3.5L GTDI—INTERMITTENT STUMBLE/MISFIRE ON ACCELERATION FROM HIGHWAY CRUISE IN HUMID OR DAMP CONDITIONS WITH POSSIBLE DTC

TSB 12-10-19

2011-2012 F-150

This article supersedes TSB 12-6-4 to remove the the production fix date, update the Title, Issue Statement, Part List and Service Procedure.

Figure 1 - Article 12-10-19

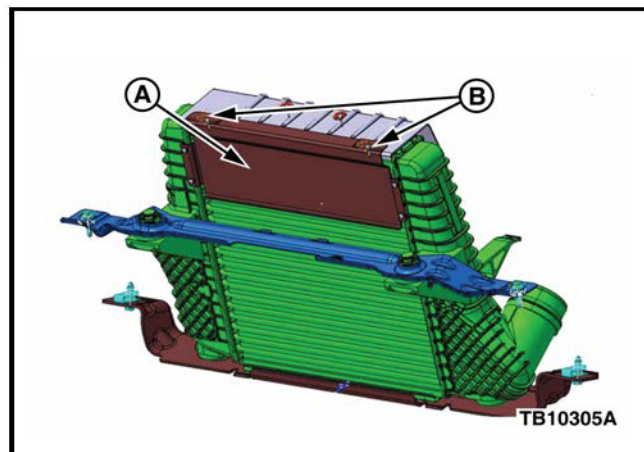
1. Check for DTC P0430. Is DTC P0430 present?
 - a. Yes - Replace the left bank catalytic converter assembly. Refer to Workshop Manual (WSM), Section 309-00. Proceed to Step 2.
 - b. No - Proceed to Step 2.
2. Is the Charge Air Cooler (CAC) equipped with an air deflector plate? (Figure 1A)

- a. Yes - Proceed to Step 5.
 - b. No - Proceed to Step 3.
3. Install a new CAC, new air deflector plate, and original shield using new retaining pushpins. Refer to WSM, Section 303-12. (Figure 1B) Proceed to Step 4.
 4. Reprogram the PCM to the latest calibration using IDS release 79.02A or higher. This new calibration is not included in the 2012.5 DVD. Calibration files may also be obtained at www.motorcraft.com.
 5. Install a new CAC and the original air deflector plate and shield using new retaining pushpins. Refer WSM, Section 303-12.
